ADDENDUM NO. 1

R/W Widening, Airfield Electrical and Pavement Rehabilitation (Base Bid)
Taxiway A Extension (Additive Alternate Bid No. 1)
at
Ennis Municipal Airport
Ennis, TX

TxDOT CSJ NO. 2618ENNIS

**R/W Widening, Airfield Electrical and Pavement Rehabilitation (Base Bid)
Taxiway A Extension (Additive Alternate Bid No. 1)(**

SHEET NAME
C705

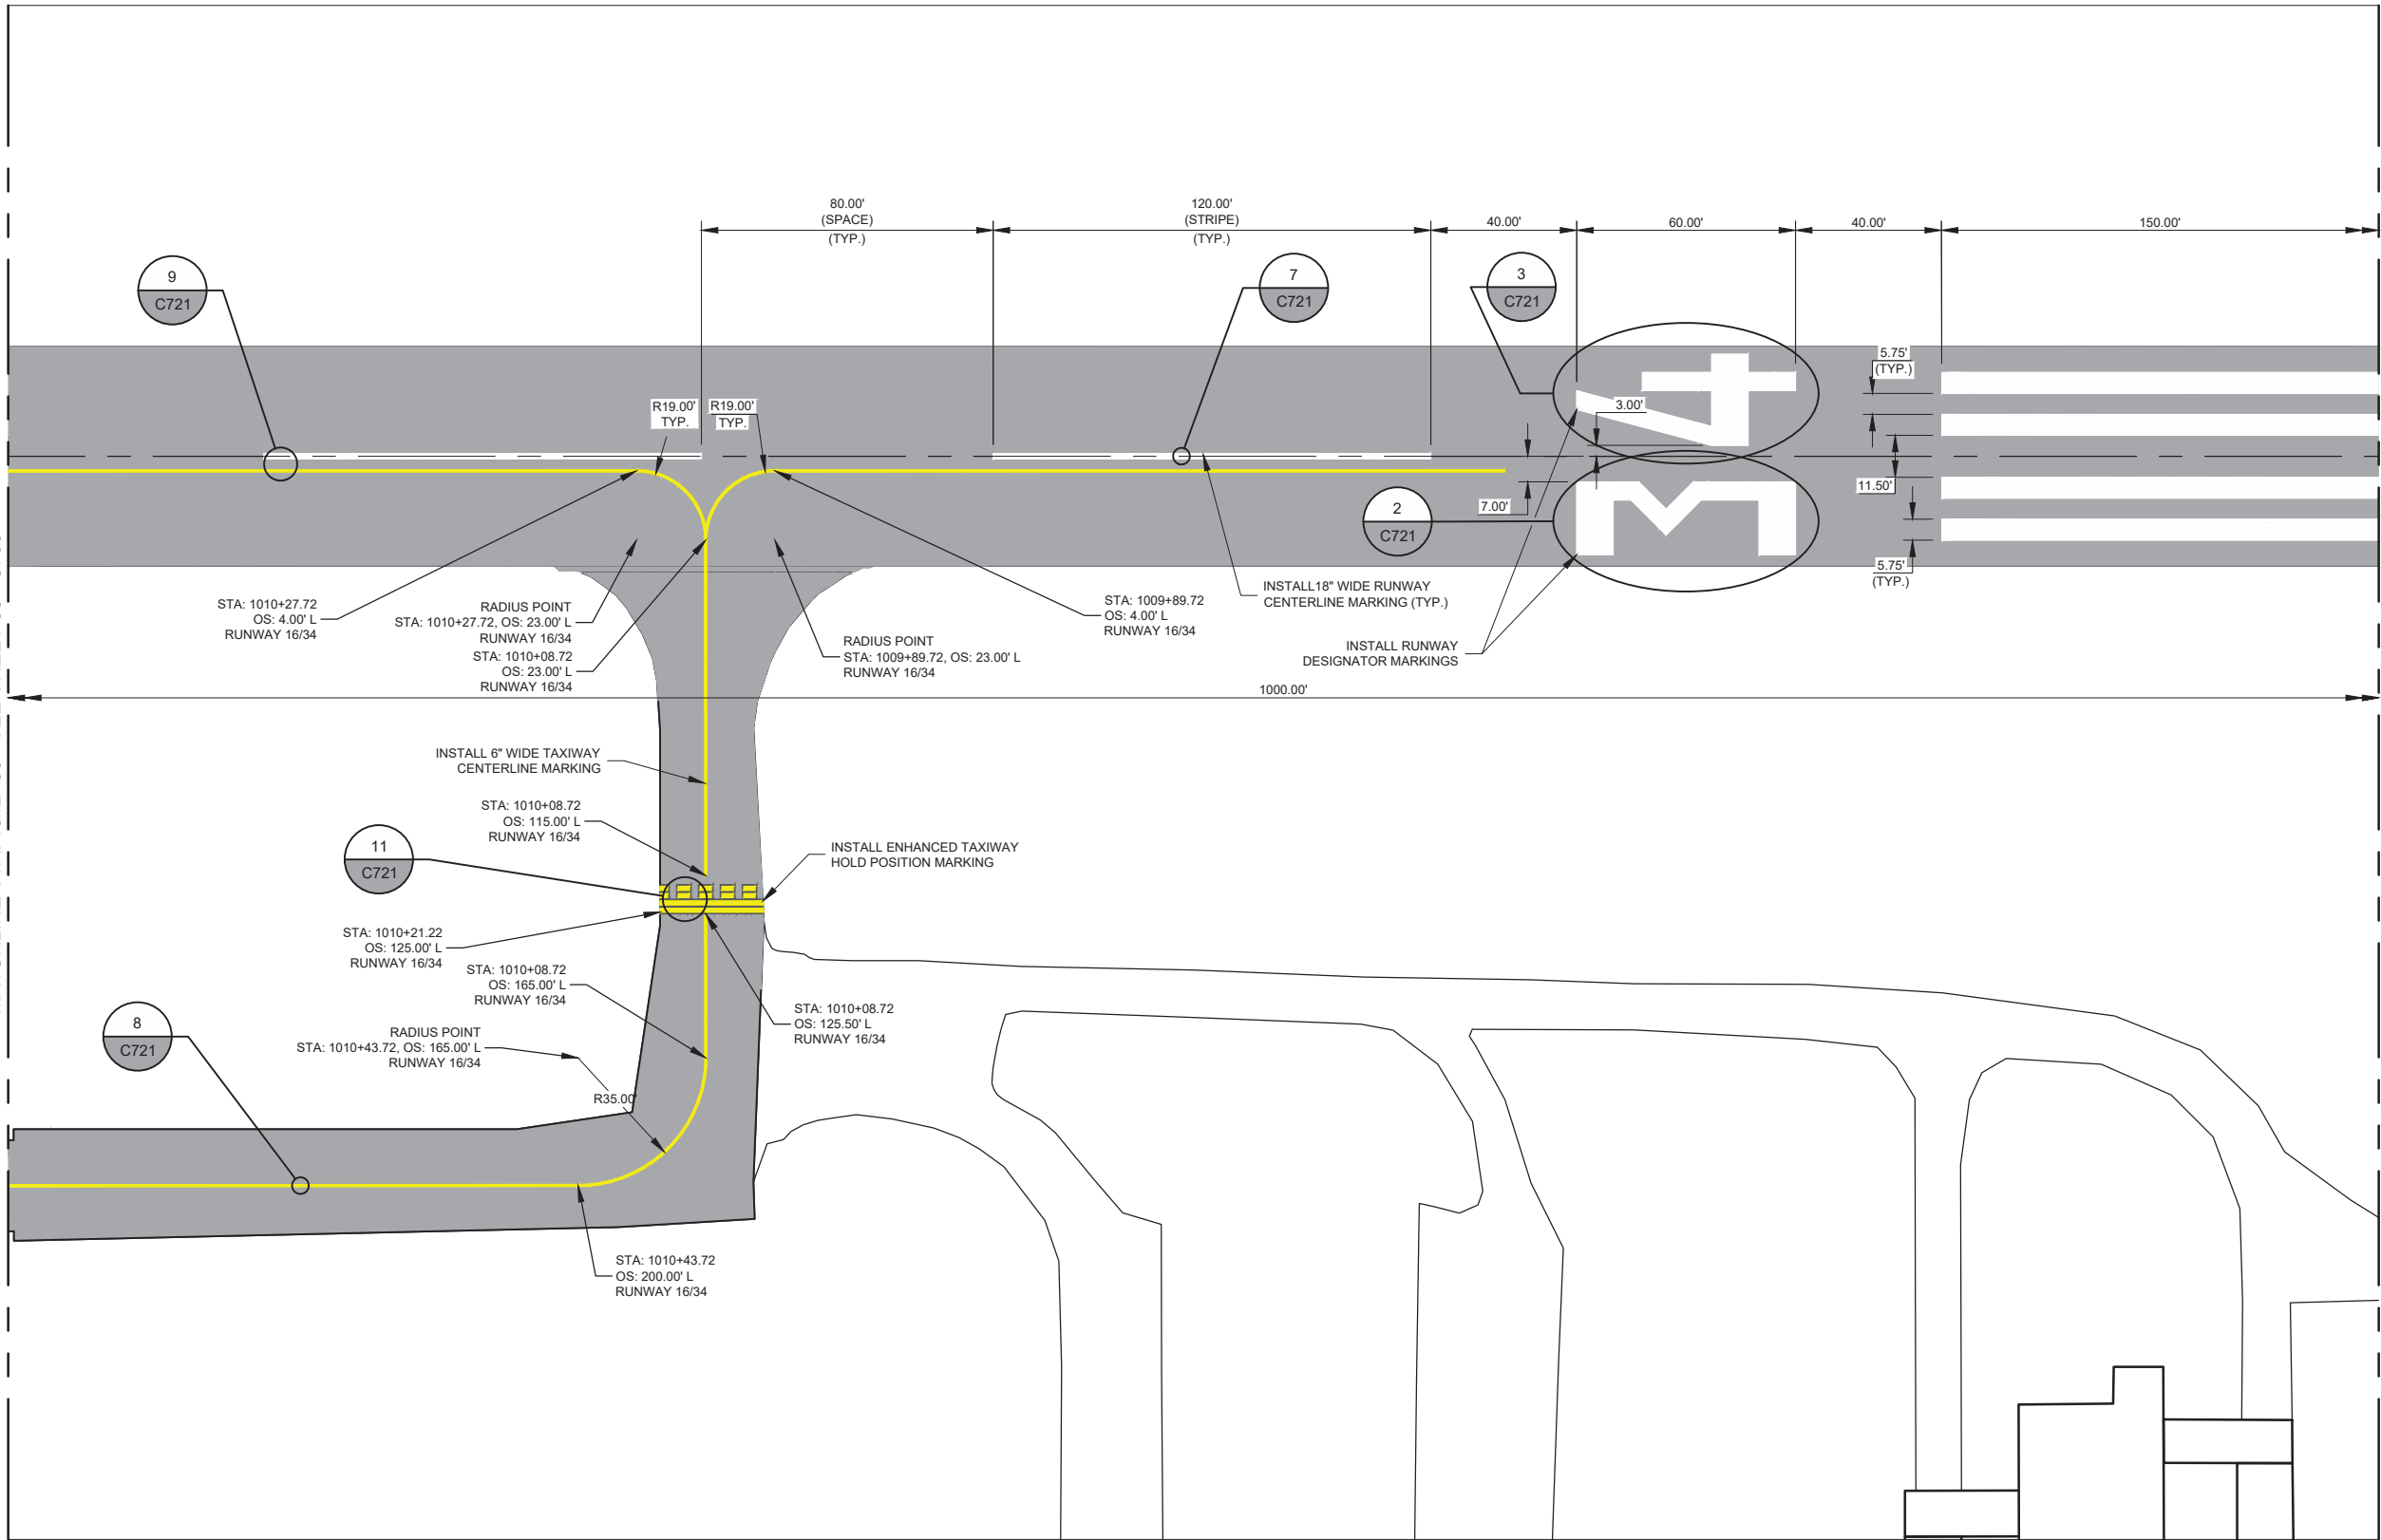
- g. Sheet C705A – Removed a reference to a marking “To Be Obliterated”. No markings require separate obliteration as they will all be obliterated by asphalt removal.

34. Confirm whether obliteration or removal of existing pavement markings is required and identify the pay item. Sheet C705A directs marking over existing markings.

E001

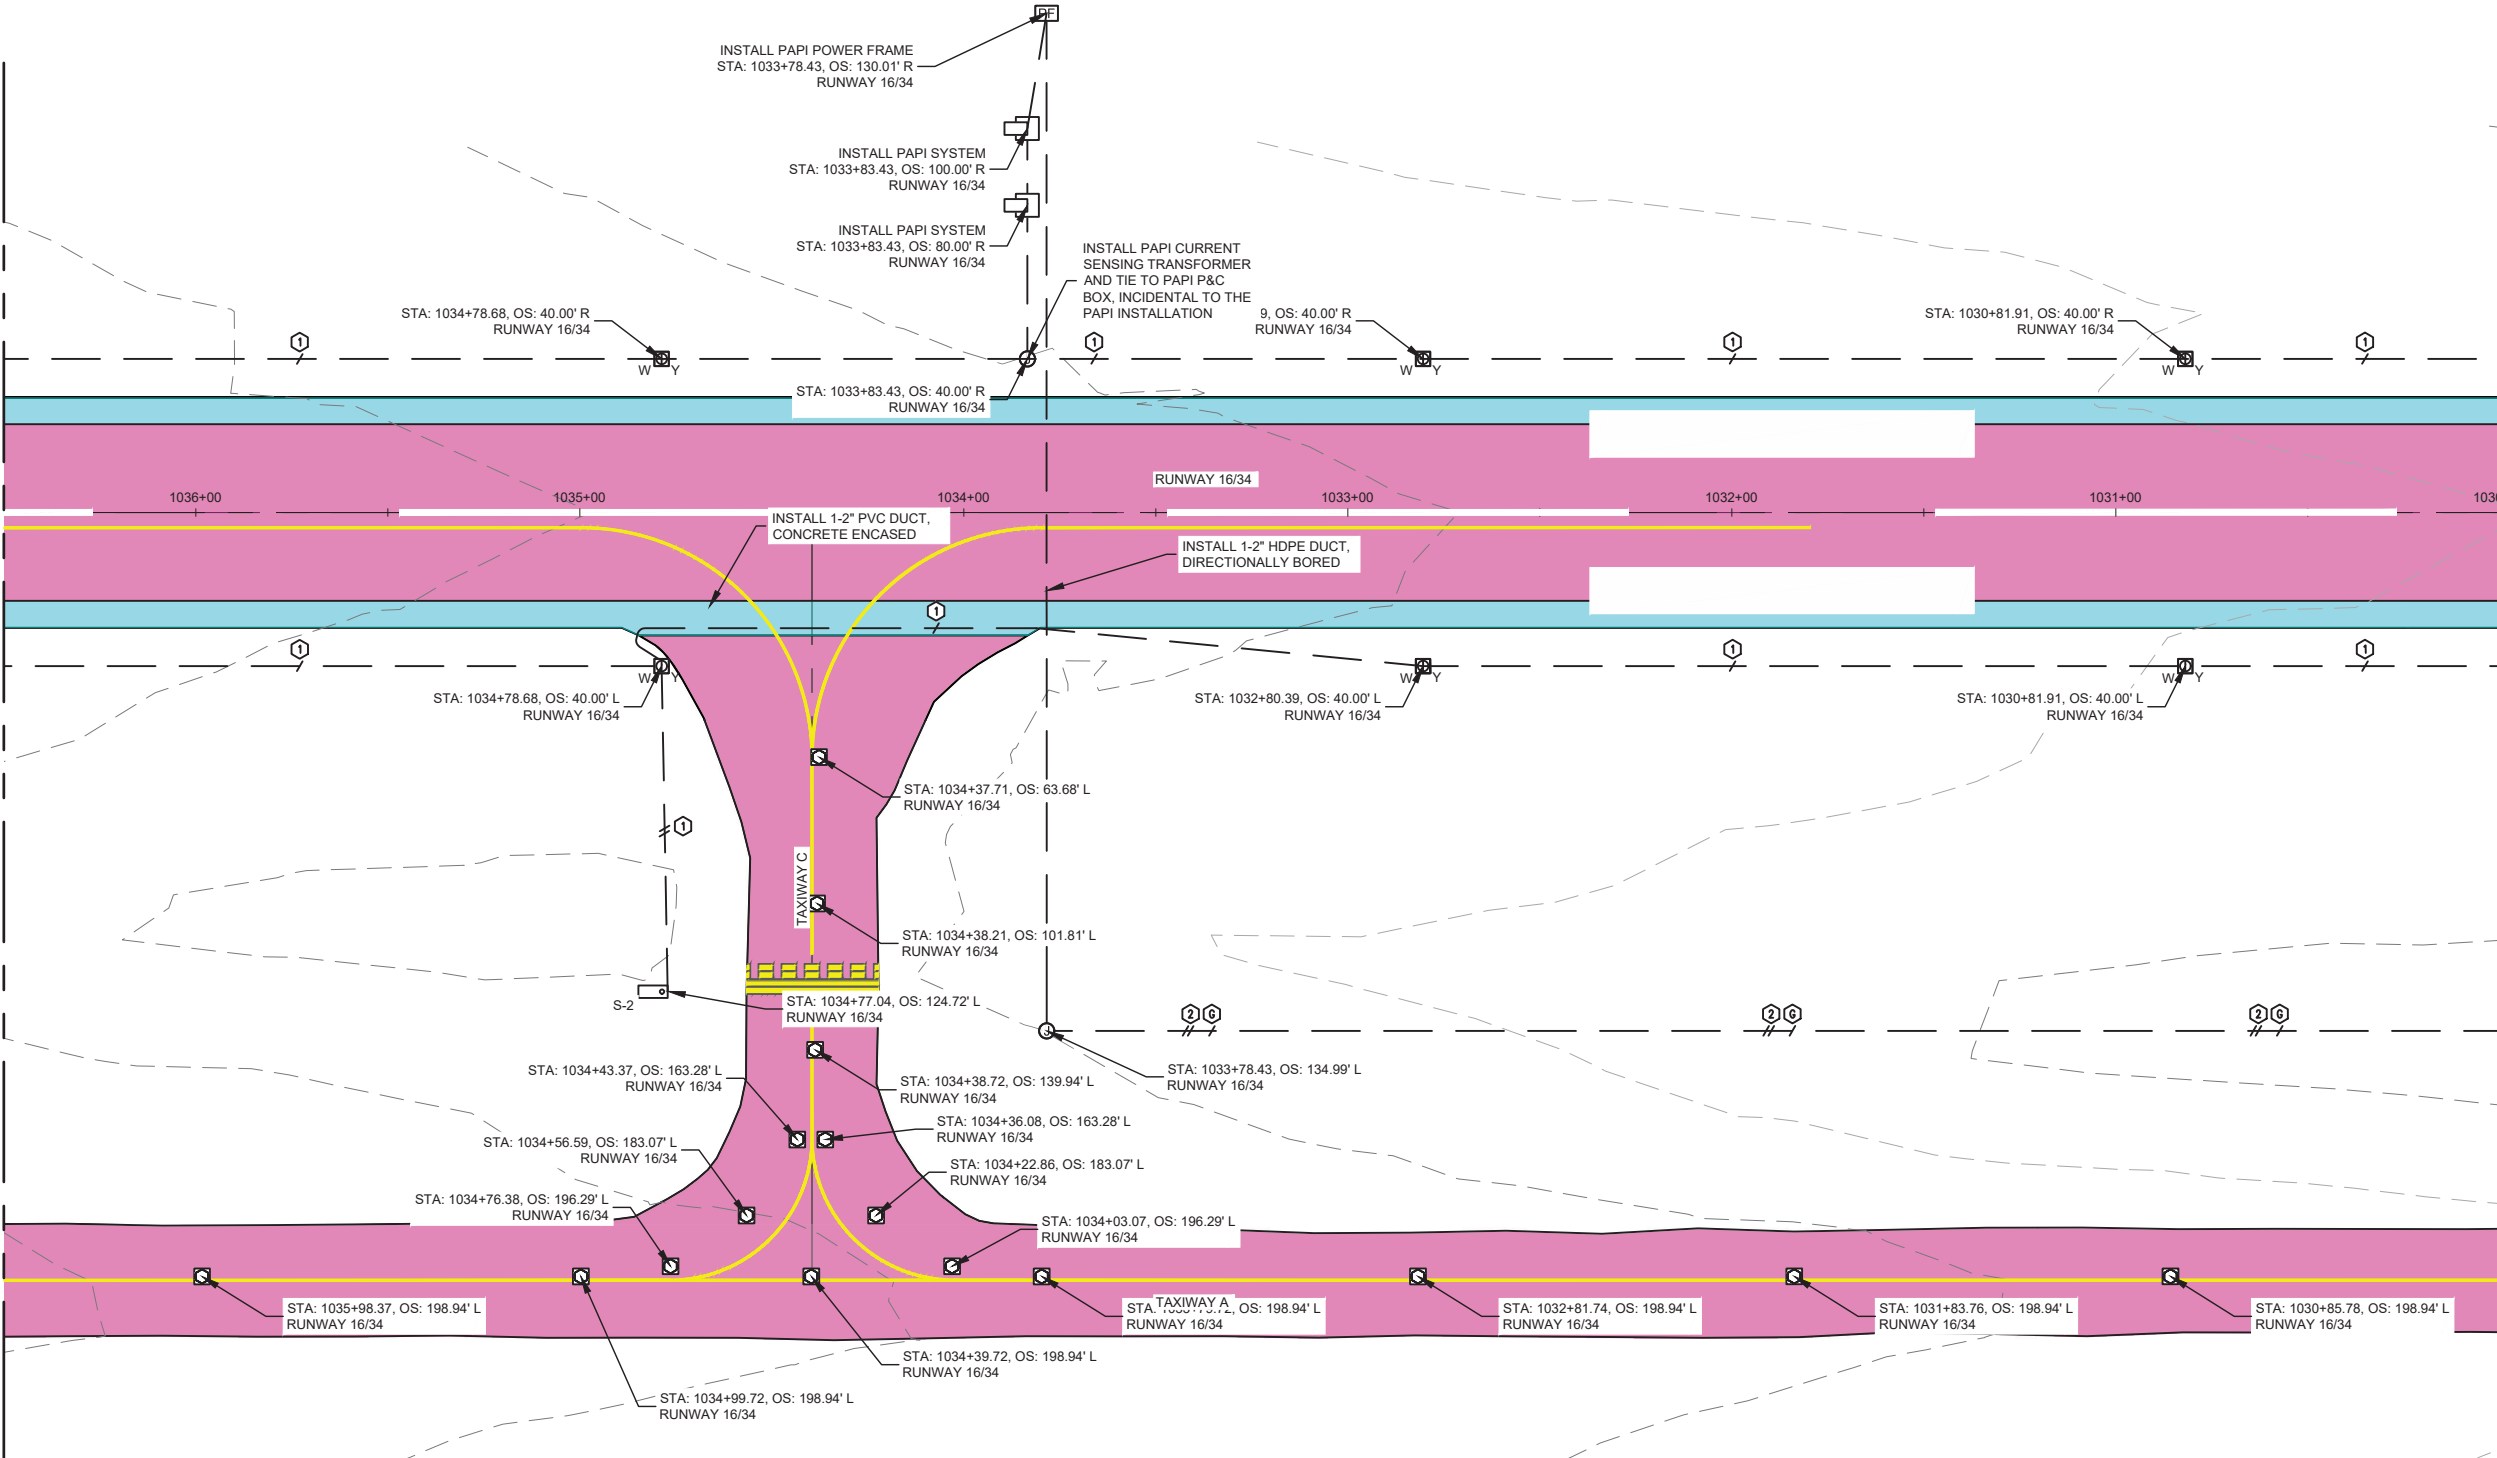
- h. Sheet E001 – Circuit Information and Lens color chart was updated. Retroreflective marker symbol description was updated.

E208

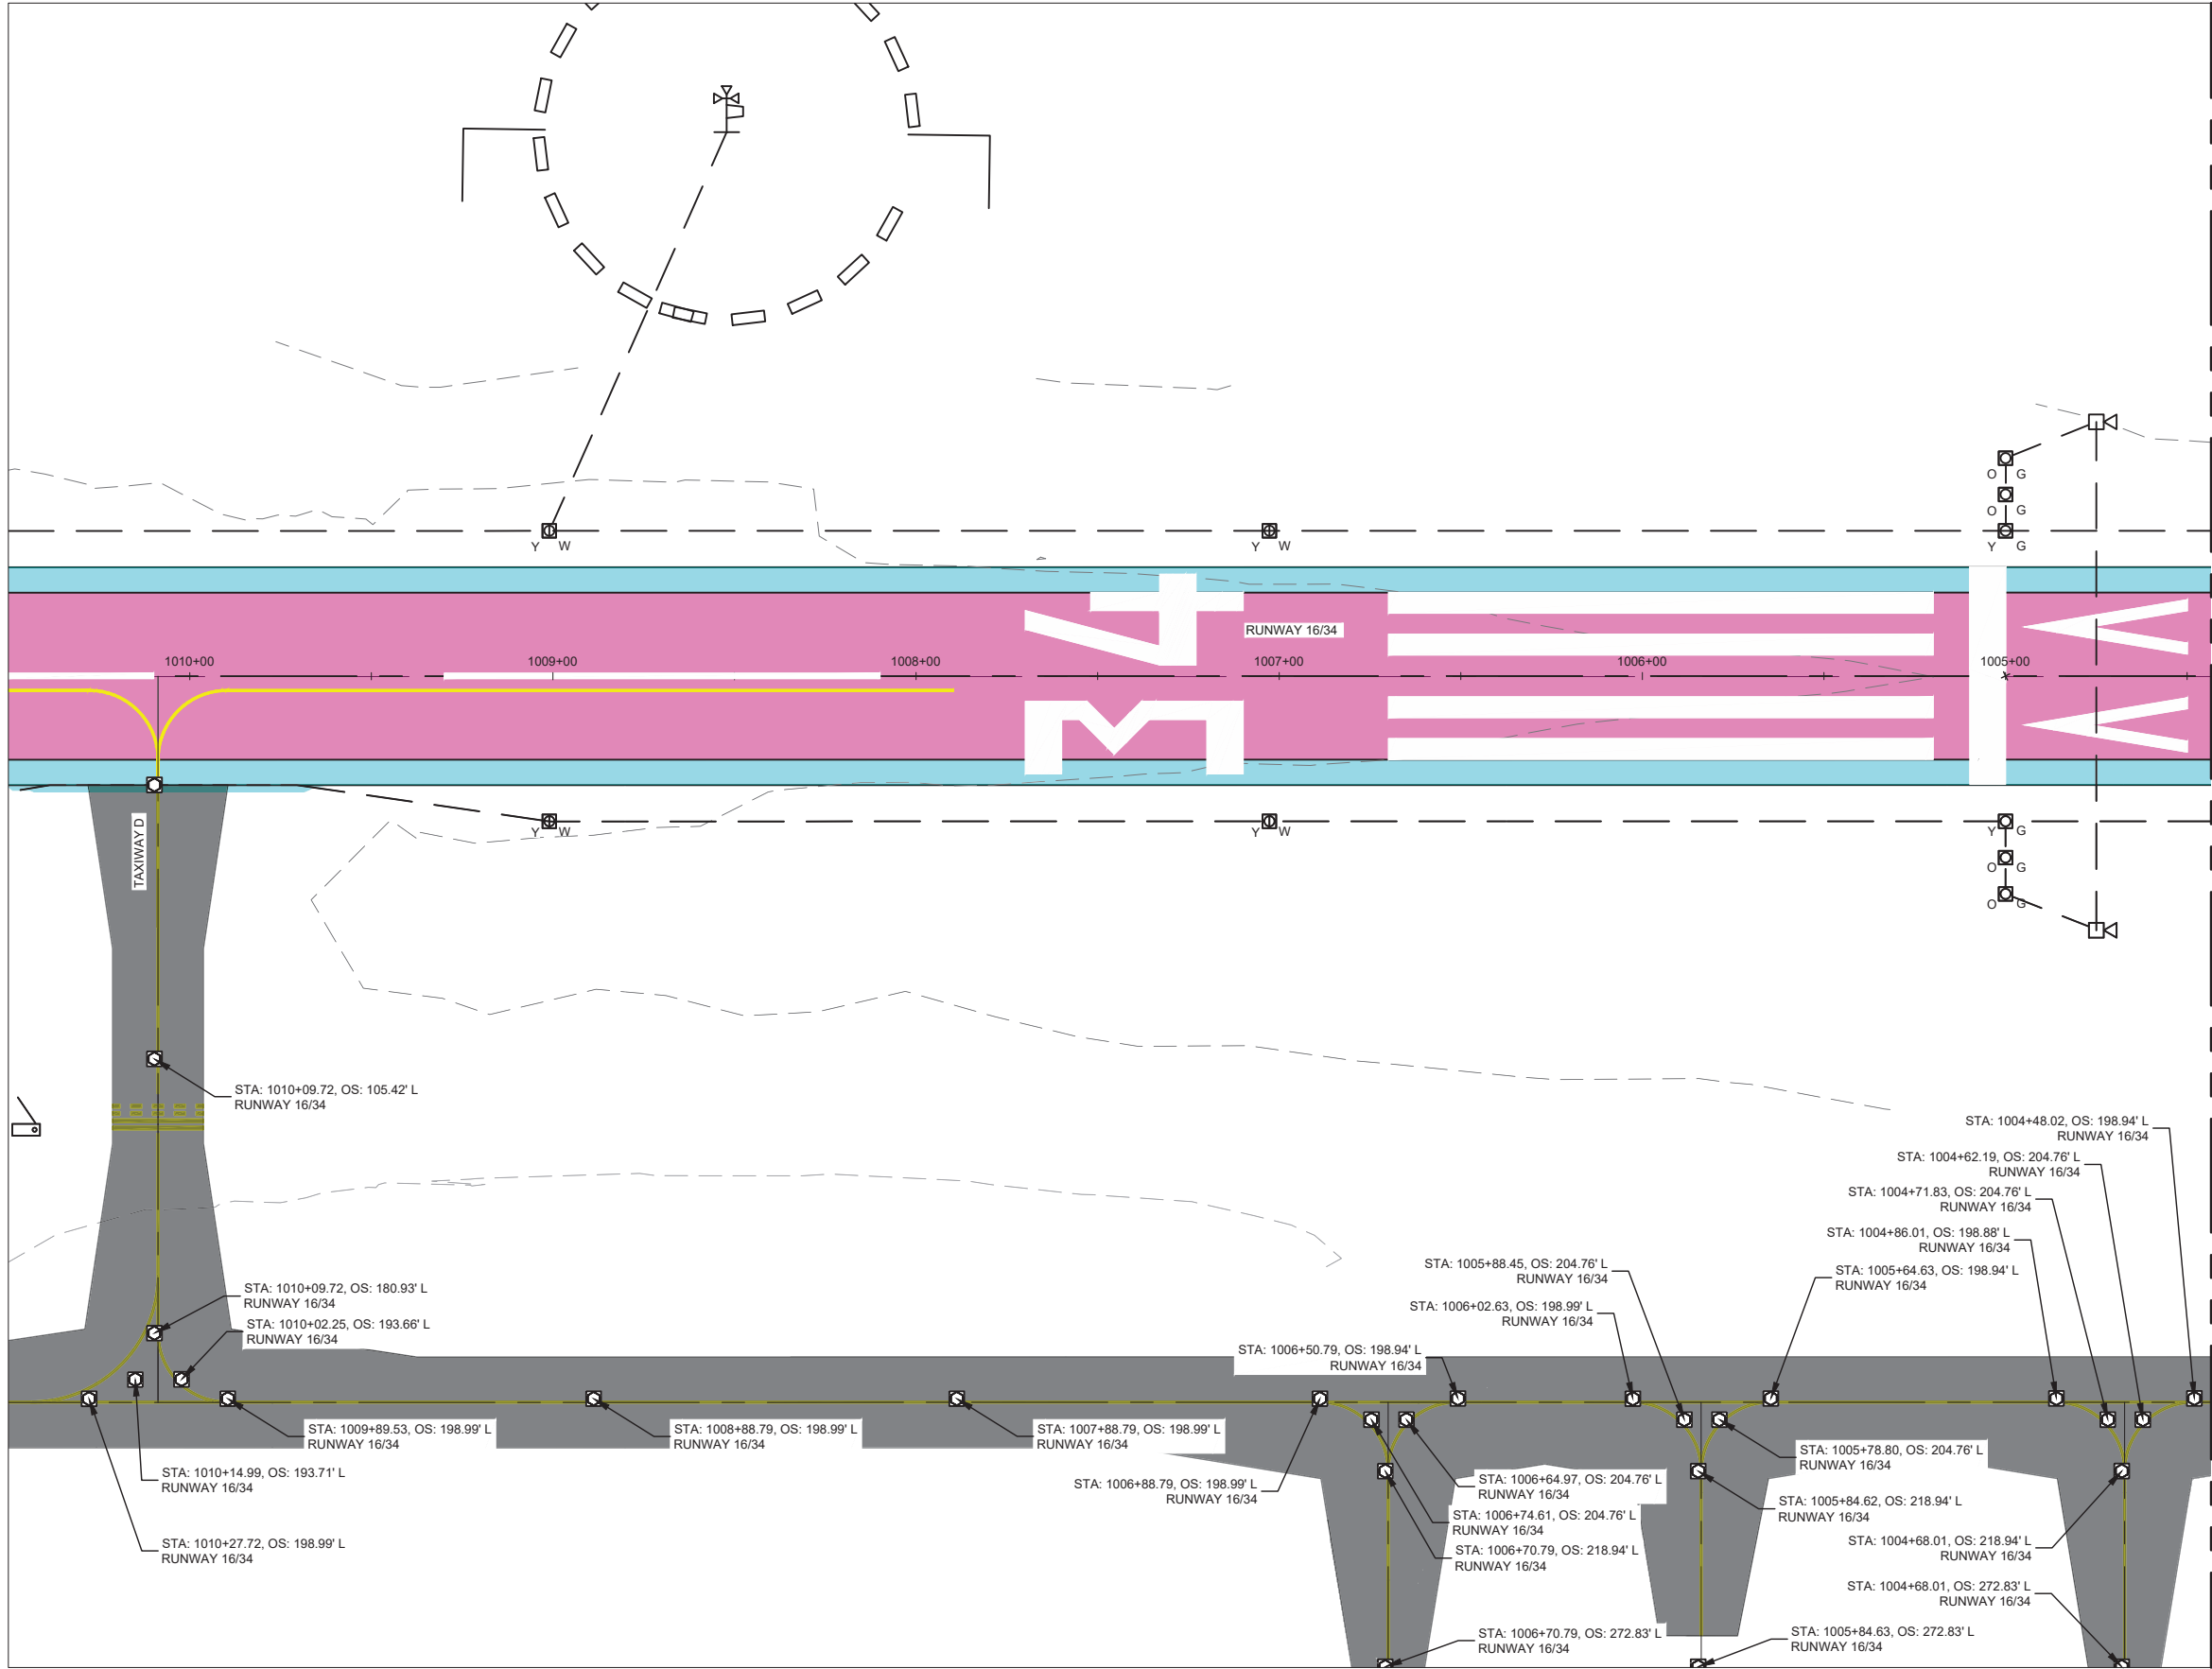
- a. Sheet E208 – The sheet was issued with airfield lighting vault and homerun information.
- b. Sheets E209 & 210 – The sheets were issued with the reflector layout for the additive bid alternative.
- c. Sheet E257 – Sheet was added with one-line diagram and panel schedule.

14. Is there a plan sheet showing the existing vault building to be removed?
A. Plan sheet E208 was added to the project. The new building will be in the same approximate location as the existing building.

15. Is there a plan sheet showing the existing beacon tower to be removed?
A. Plan sheet E208 was added to the project. The new beacon tower will be in the same approximate location as the existing building.

16. Is there a plan sheet showing the location of new vault building?
A. Plan sheet E208 was added to the project.
17. Is there a plan sheet showing the location of the new beacon pole?

A. Plan sheet E208 was added to the project.
18. Is there a plan sheet showing the home run from the airfield lights to the vault building.
A. The home run was added to the plans.
